May 23, 2008

Additional Information for
Application to Amend Special Use Permit File No. 72/SUP-1
Makakilo Quarry: Grace Pacific Corporation
Tax Map Keys 9-1-16: 4; 9-2-2: 6; and 9-2-3: 74 and 82

**MAKAKILO QUARRY
(Tax Map Key 9-2-3: 82)
CONDITIONAL USE PERMIT NO. 72/CUP-15
ENGINEERING REPORT AMENDMENT**

Figure 5b (part 5 of 9)

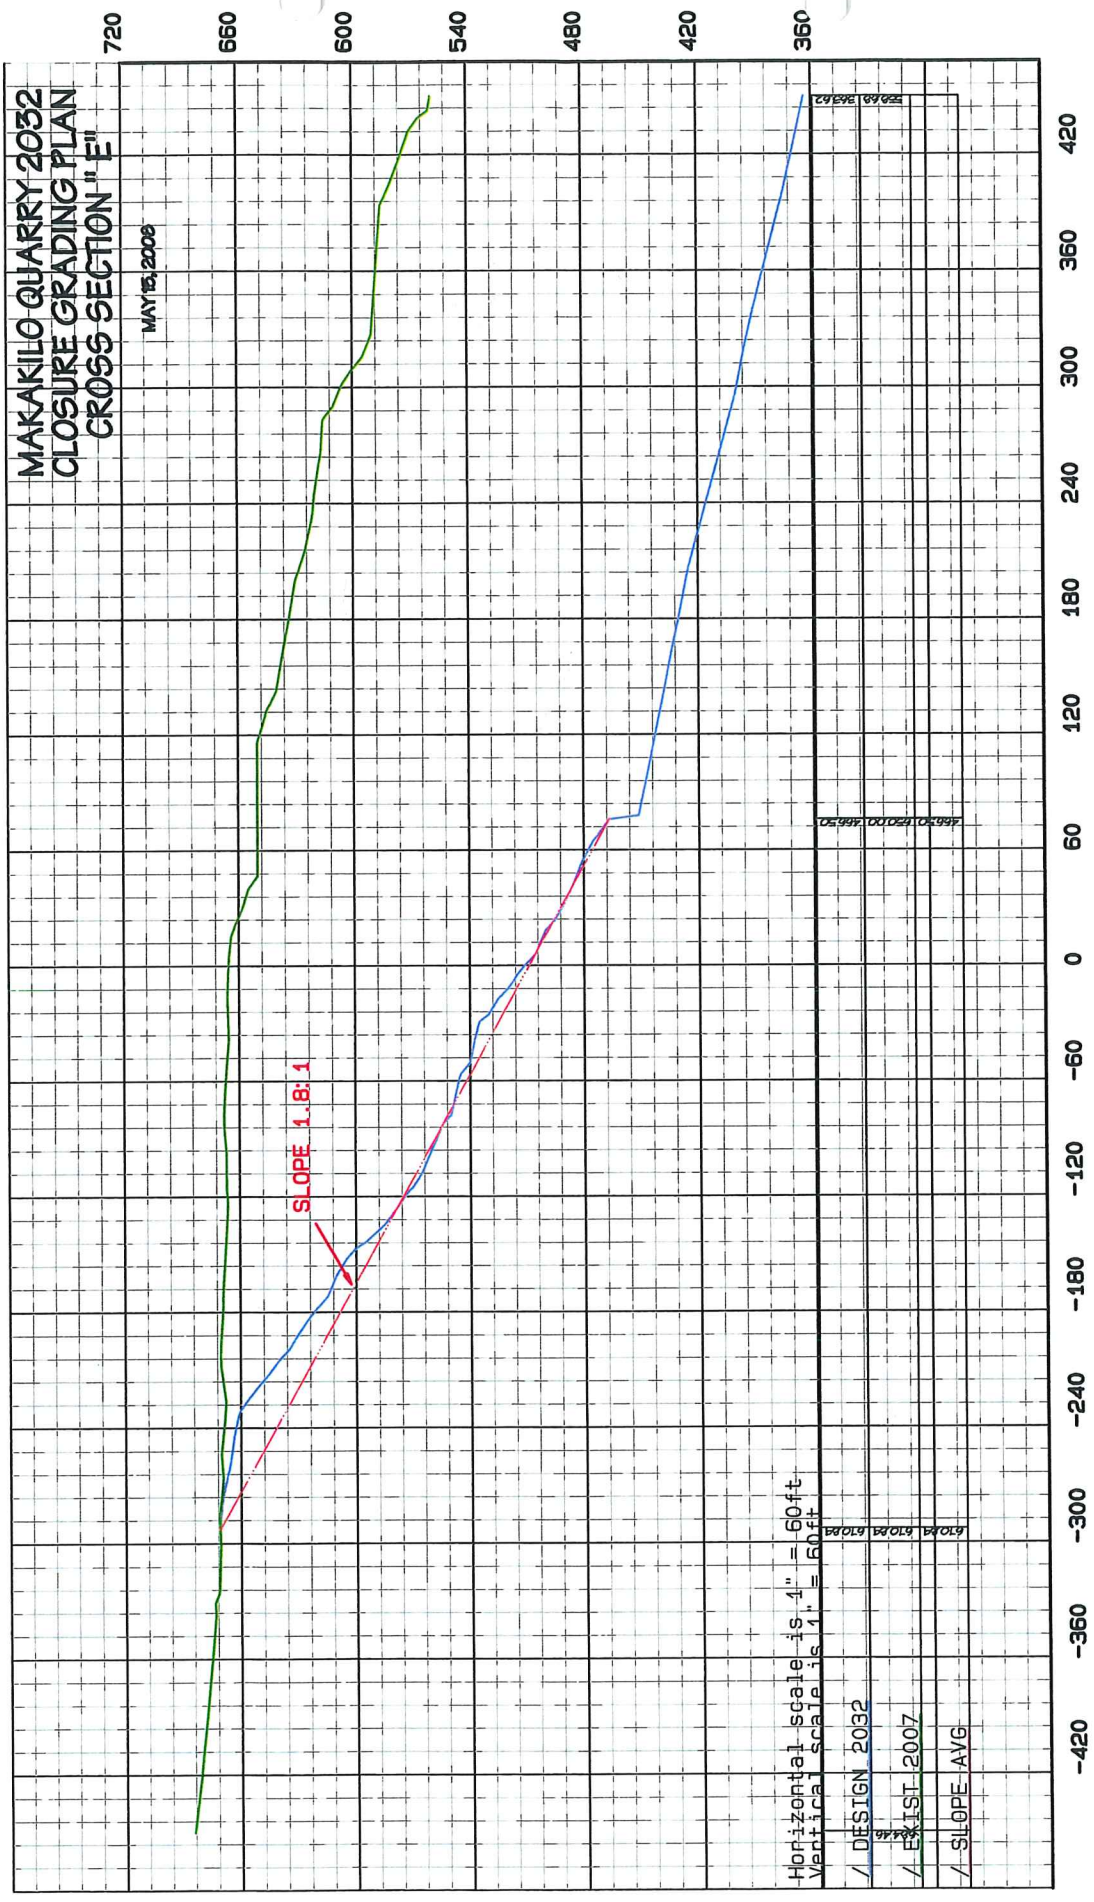
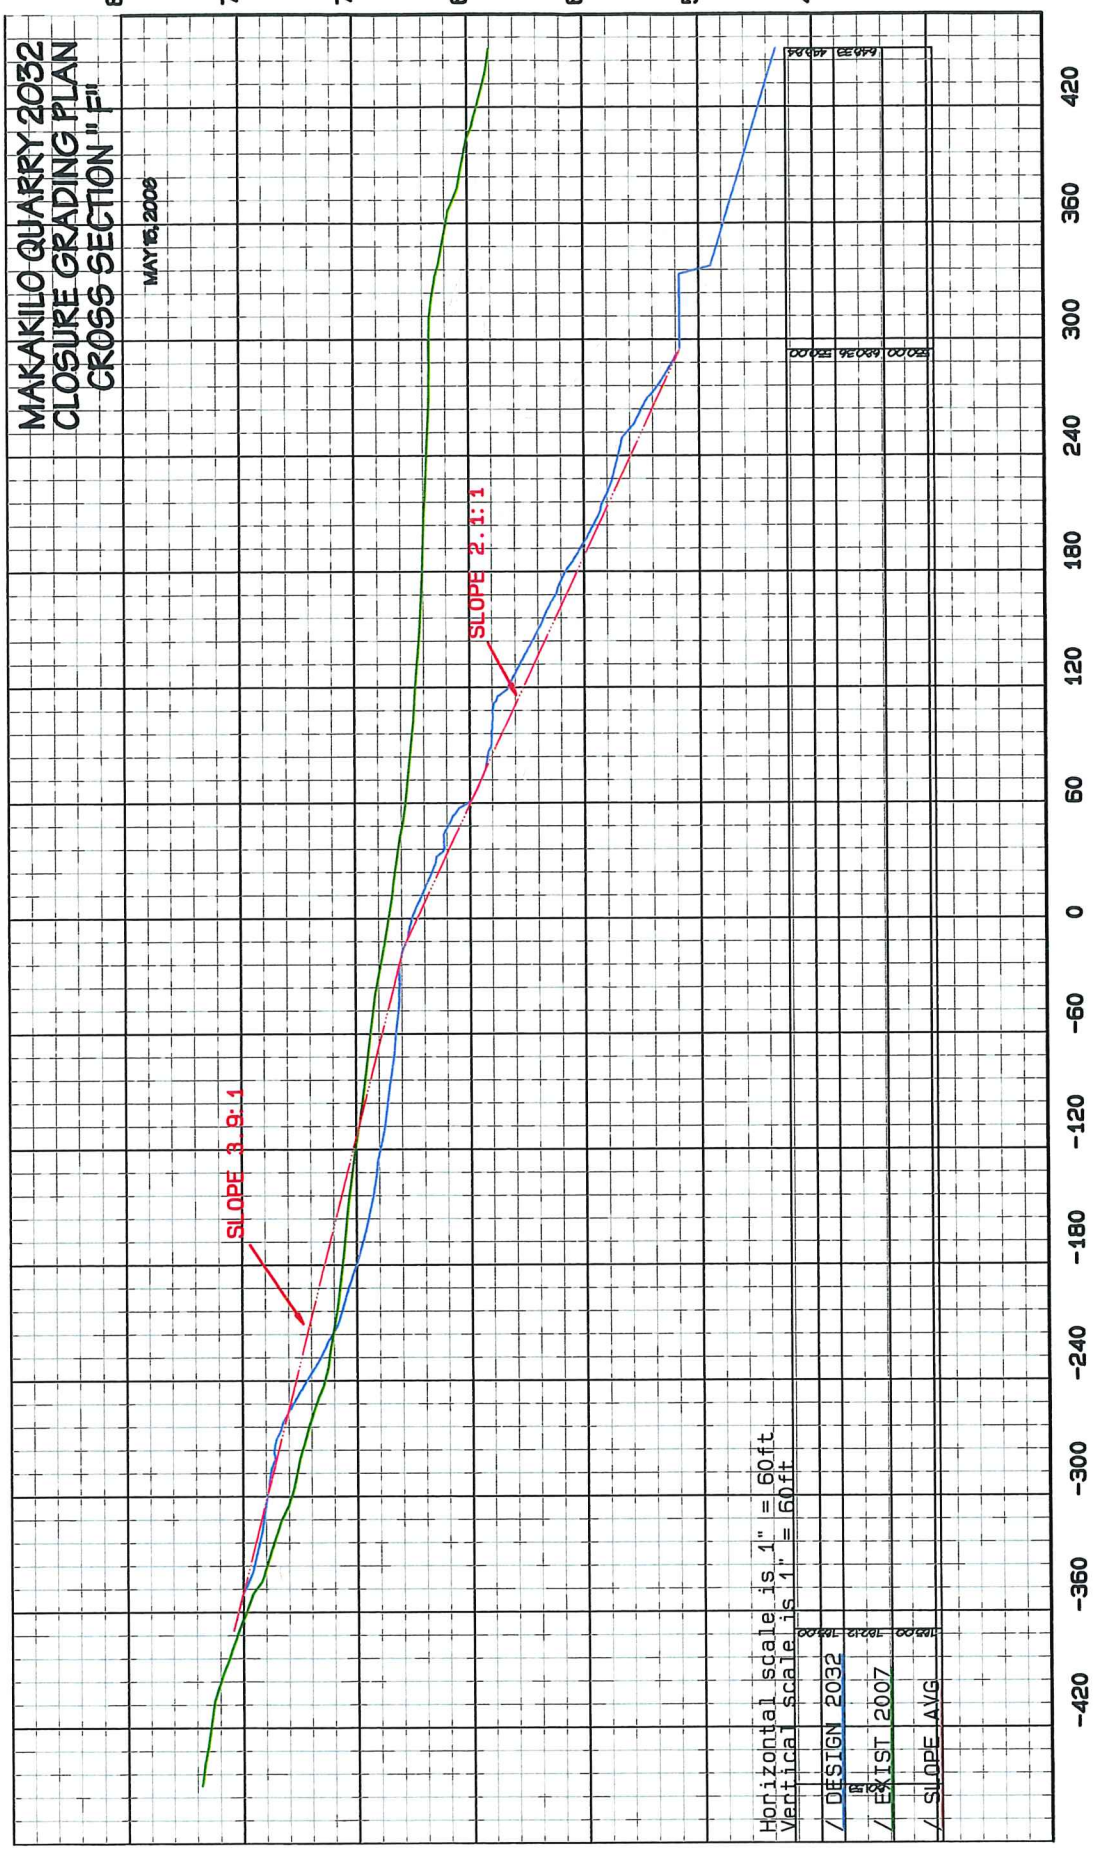
- c) Revised Figure 5a "Closure Grading Plan with Cross Section Index" in Appendix B of Exhibit K "Engineering Report Amendment" of the Application.
- d) Revised Figure 5b1 - Bb9 "Cross Sections AA through II", accompanying revised Figure 5a.
